Technical Service BULLETIN

Title: CHARGE WARNING LIGHT "ON" Models: '03 – '05 4Runner (V6)

REVISSED
EL006-05
ELECTRICAL

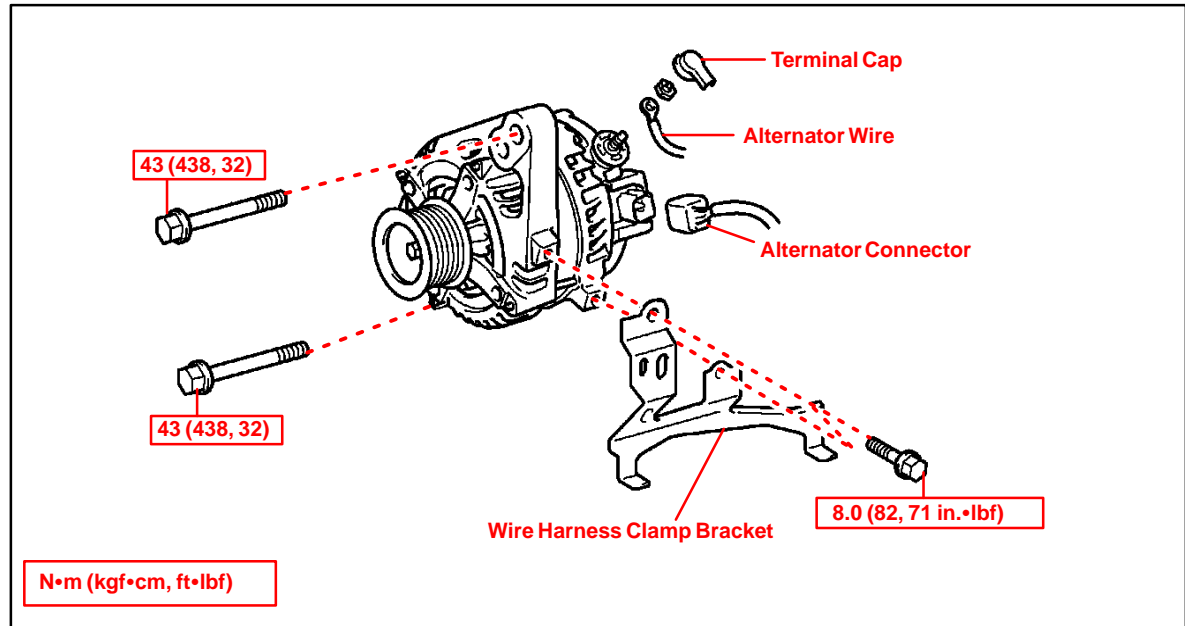
1. Remove and replace the alternator with the updated part.

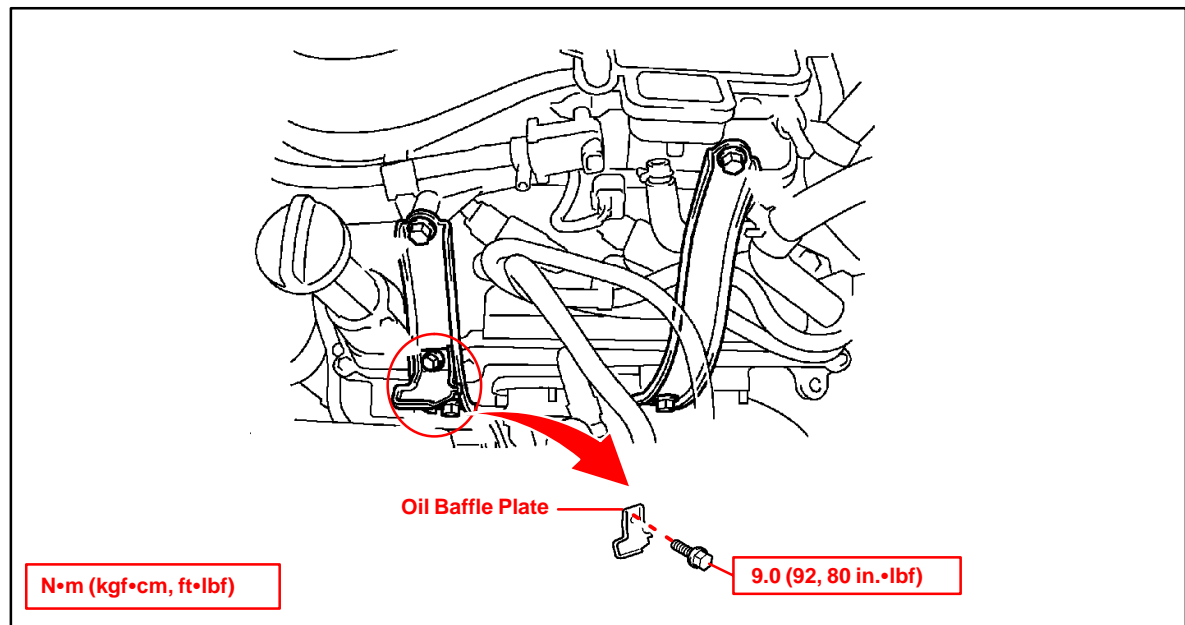
2. Remove and replace the oil baffle plate (found on the driver's side bolted to the engine intake brace) with the updated part.
